REVISED RESPONSE TO REQUEST FOR ADDITIONAL INFORMATION

APR1400 Design Certification

Docket No. 52-046

RAI No.: 269-8319
SRP Section: 09.02.02 - Reactor Auxiliary Cooling Water Systems
Application Section: Section 9.2.7
Date of RAI Issue: 10/22/2015

Figure 9.2.7-1 Essential Chilled Water System Flow Diagram (Sheet 3 of 4)

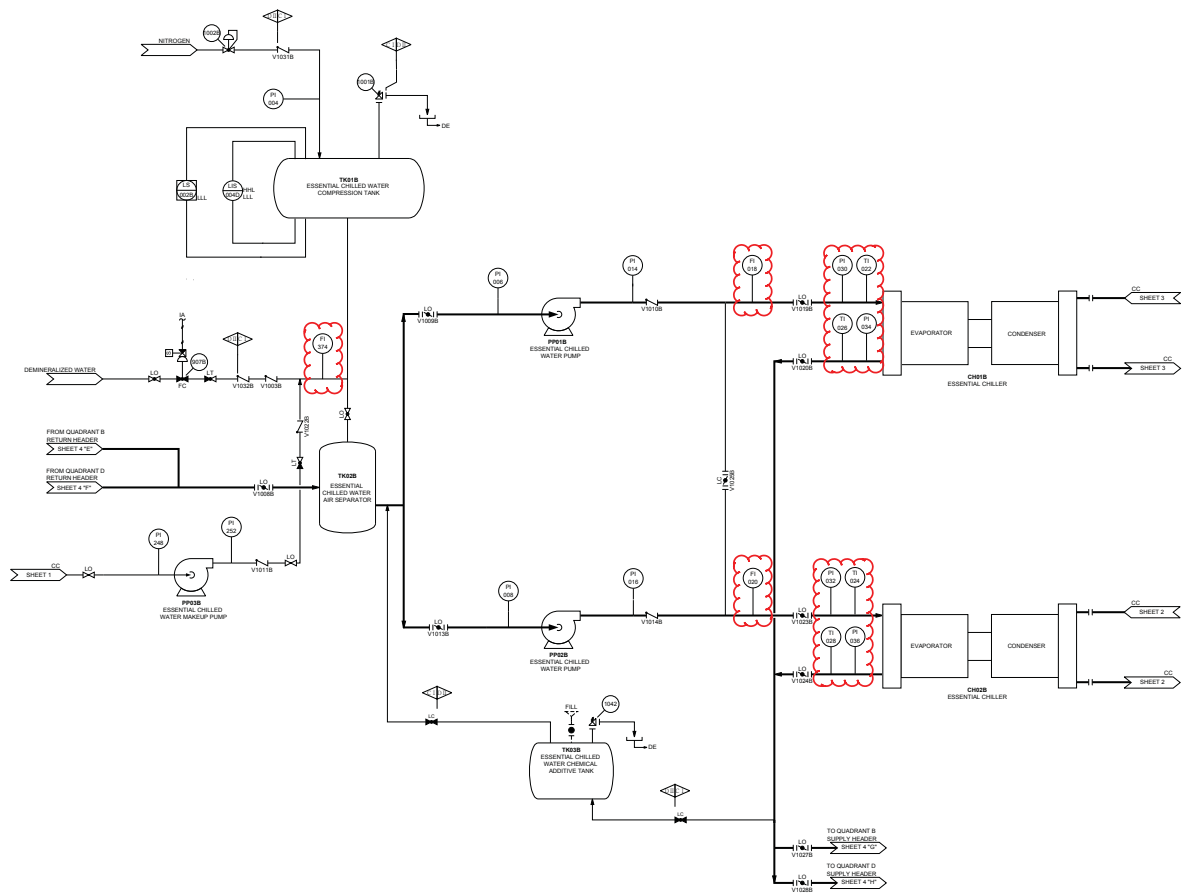
- a) DCD Tier 2, Section 9.2.7.5 states "local temperature and pressure indicators are provided at selected points in the system;" however, it is unclear to the staff if this information is included on Figure 9.2.7-1.
- b) DCD Tier 2, Section 9.2.7.5 specifies that inlet and outlet pressure of the evaporators are provided; however, this is not shown on Figure 9.2.7-1.
- c) DCD Tier 2, Section 9.2.7.5 provides a list of main control room (MCR) and remote shutdown room (RSR) indication and alarms; however, it is not clear to the staff what control instrumentation is available to the operators and which instruments provide the input to specific indication or alarms.
- d) DCD Tier 2, Section 9.2.7.5 or Figure 9.2.7-1 do not include instrumentation, controls, or alarms for protection against freezing, high/low refrigerant pressure, refrigerant leak detection, flow, and temperature.

- a) Local temperature, flow, and pressure indicators will be added to the figure 9.2.7-1.
- b) Inlet and outlet pressure indicators of the evaporators will be added to the figure 9.2.7-1.

APR1400 DCD Tier 2, **Section 9.2.7.5 and** Figure 9.2.7-1 will be revised as indicated in the Attachment.
